QVM Bulletin: Q-266R1

2017 to 2020 Model year F-Series Dual/Single Alternator Conversion

Models Affected: 2017 and later F-Super Duty F-250/350/450/550 with dual alternators

2020 P558 7.3L Gas Engine FEAD

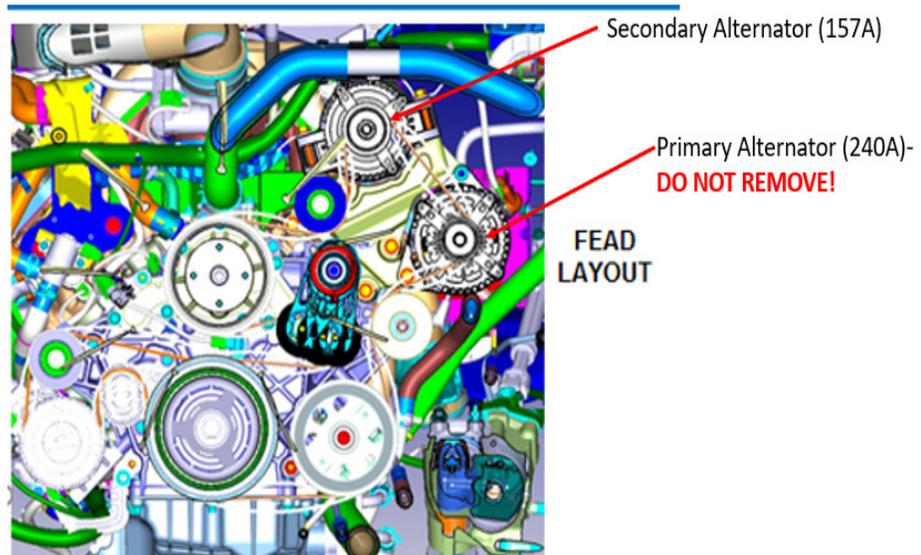
If one of the alternators must be removed the secondary alternator must be chosen.

Extreme caution must be taken when removing the secondary alternator to ensure that in some cases, battery managements systems are used to mitigate starting problems.
